- Subject : Extension-retraction unit, rear fork of spindle-drive
- Effectivity : DG-800 variants DG-800B (with spindle-drive Stross) and DG-808C  
DG-500M variant DG-500MB

- Reason : To increase the fatigue life of the rear fork of the spindle drive a new fork was  
designed which is milled from a steel block. This replaces the original welded fork  
With DG-808C ser. no. 8-408 up to 8-410 and from ser. no. 8-412 on the fork will  
be screwed directly into the push tube of the spindle drive.

drawing 8M227 issue i

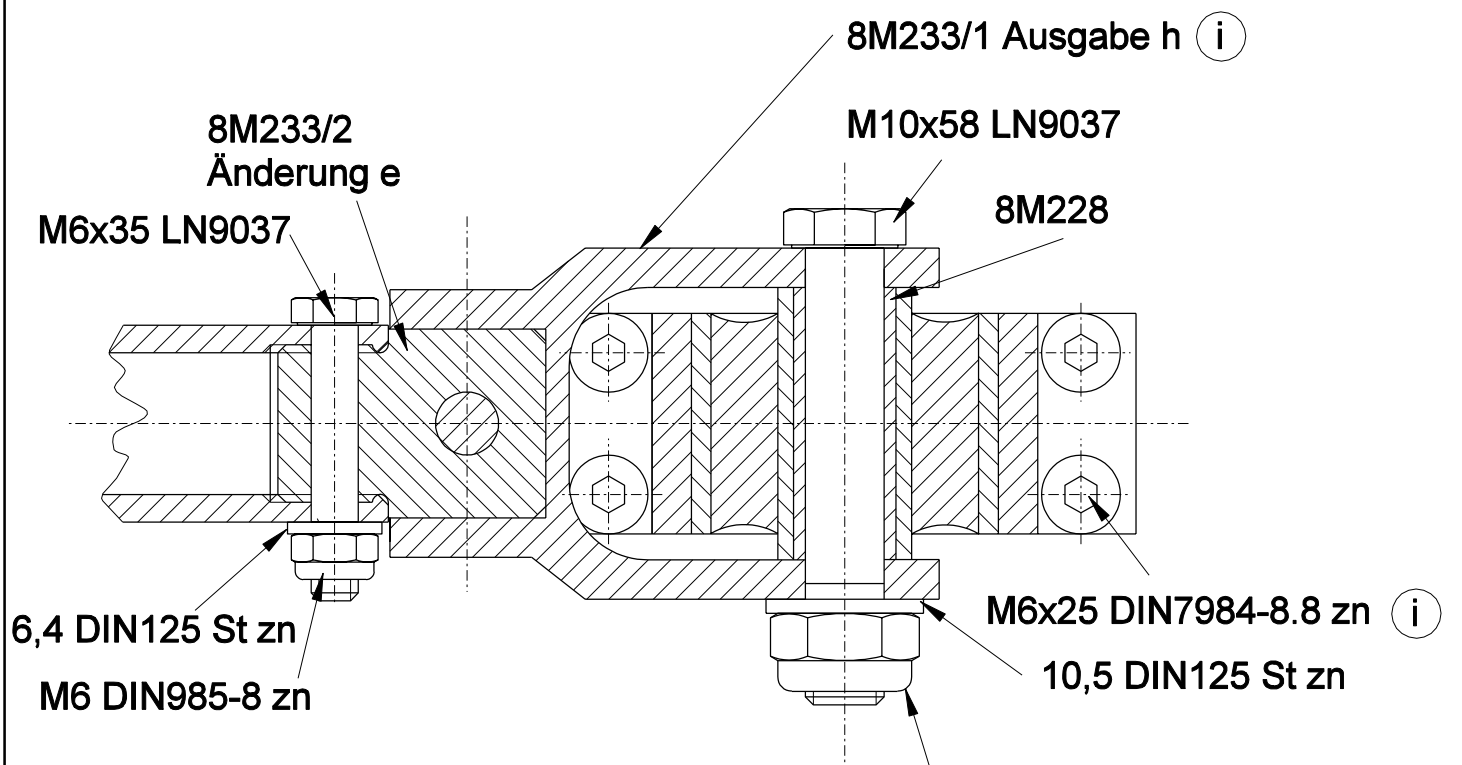
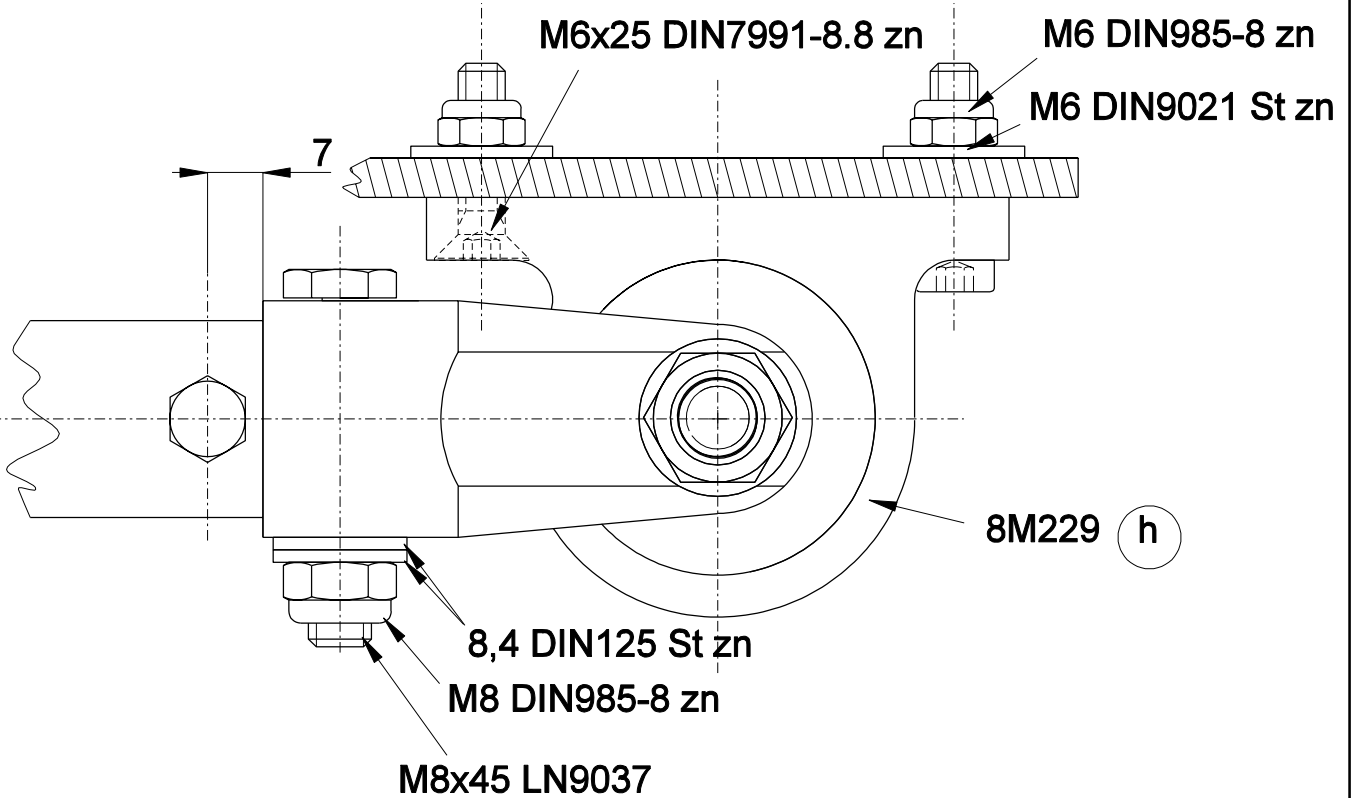
- Instructions : 1. DG-800B and DG-500MB and DG-808C up to ser. no. 8-402, ser. no. 8-404 up  
to 406 and 8-410:  
The fork 8M233/1 (drawing issue h) may be installed instead of the welded fork  
without further modifications, but use only 1 washer between nut and fork at the  
M10 bolt, see drawing 8M227 issue i.

X= Wenn 8M233 Ausgabe h als Ersatzteil  
 DG-800B und DG-808C bis W.Nr. 8-402,  
 8-404 bis 406 und 8-410  
 DG-500MB alle W.Nr.
